**RE: Supplemental Package #1
 Hinata Resort
 133 Warfield Road,
 Charlemont Massachusetts**

Hinata Mountainside Resort Special Permit Report to the Charlemont Planning Board, 4/4/2024

Responses in Bold Arial text

Figure #3

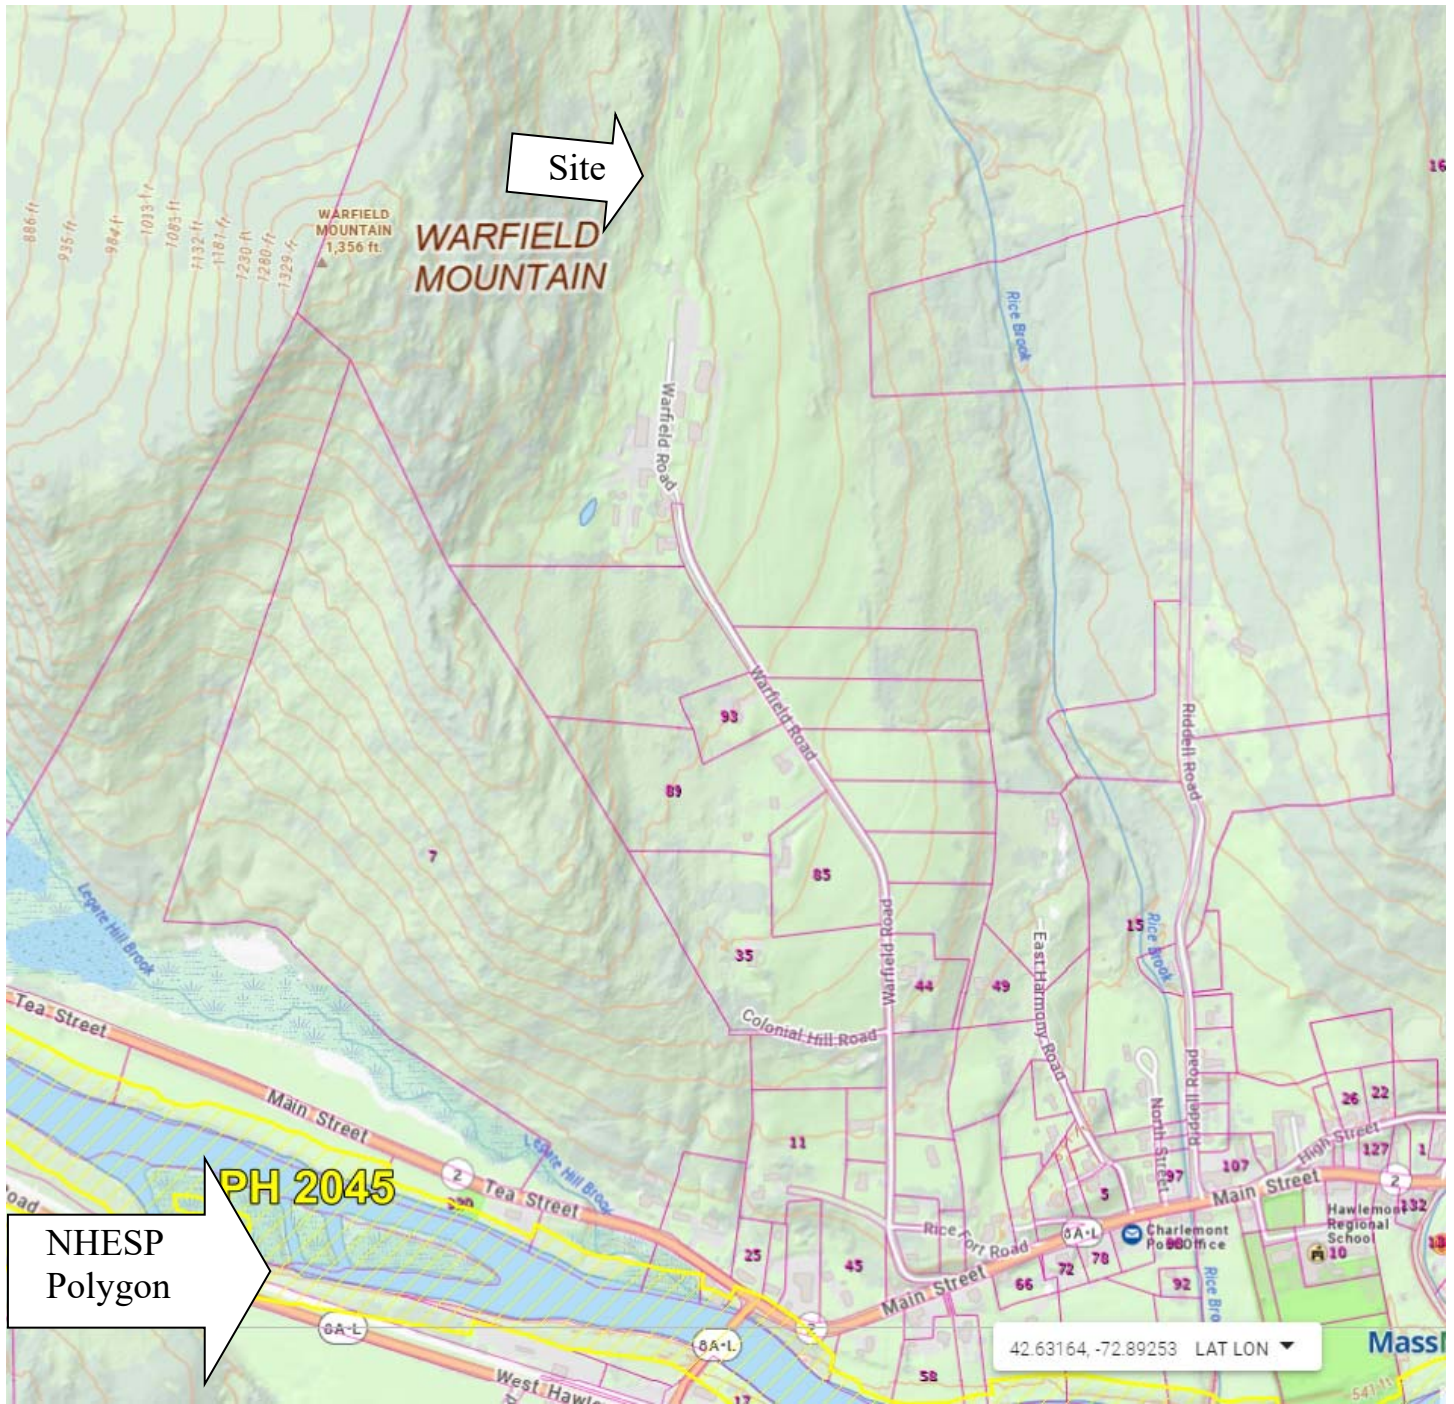
4. BioMap: Is any portion of the project area within state designated BioMap areas? The site appears to be BioMap Critical Natural Landscape.

"BioMap areas are intended for conservation planning purposes only and should not be used for regulatory purposes. The NHESP layers designed for regulatory use are produced in the Natural Heritage Atlas and include Priority Habitat and Estimated Habitat." according to the Mass. Division of Fisheries and wildlife website.

The proposed project is NOT within any NHESP regulated areas.
